# SERVICE BULLETIN

## REPLACEMENT OF PIN PART NO. 929700 IN CARBURETOR FOR ROTAX® ENGINE TYPE 912/914 (SERIES) SB-912-048 SB-914-033

Replacement of pin part no. 929700 in carburetor for ROTAX® Engine Type 912/914 (Series)

engine  
912/914

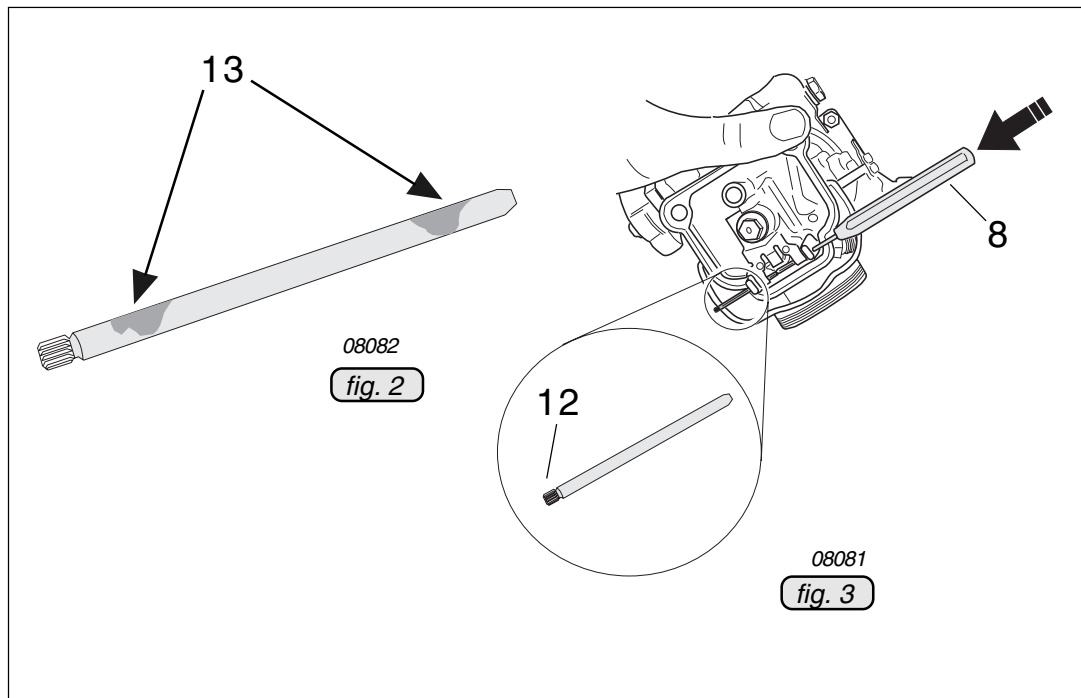
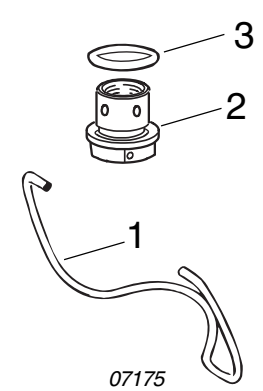
In limited cases a production deviation of the pin in the carburetor may lead to flaking of the surface coating and may cause contamination in the float chamber.

- Disconnect negative terminal of aircraft battery.
- Remove drip tray - if equipped.
- Remove carburetor.
- Open spring clip (1) or ROTAX® 914 (Series) open attachment screw (2) with o-ring (3).
- Remove float chamber (4) with gasket (5) and float (6).
- Remove pin (7) with appropriate pin punch (8) and remove float bracket (9) with float needle clip (10) and float needle valve (11)

◆ **NOTE:** The pin is serrated on one side (12). Put the pin punch on the opposite side and press out the pin. Don't damage the carb casting by pressing the serrated end through the pin support.

- Inspect the pin for flaking (13) of surface coating.
- Clean carburetor and fuel system, especially in case of flaking on the pin
- Check parts of carburetor.
- Install float bracket with float needle clip/float needle valve and the new pin part no. 929701
- Check if float suspension brackets are parallel and adjust if necessary.
- Install float chamber with gasket and float.
- Reassemble the carburetor.
- Install carburetor.
- Install drip tray - if equipped.
- Connect negative terminal of aircraft battery.
- perform basic throttle adjustment
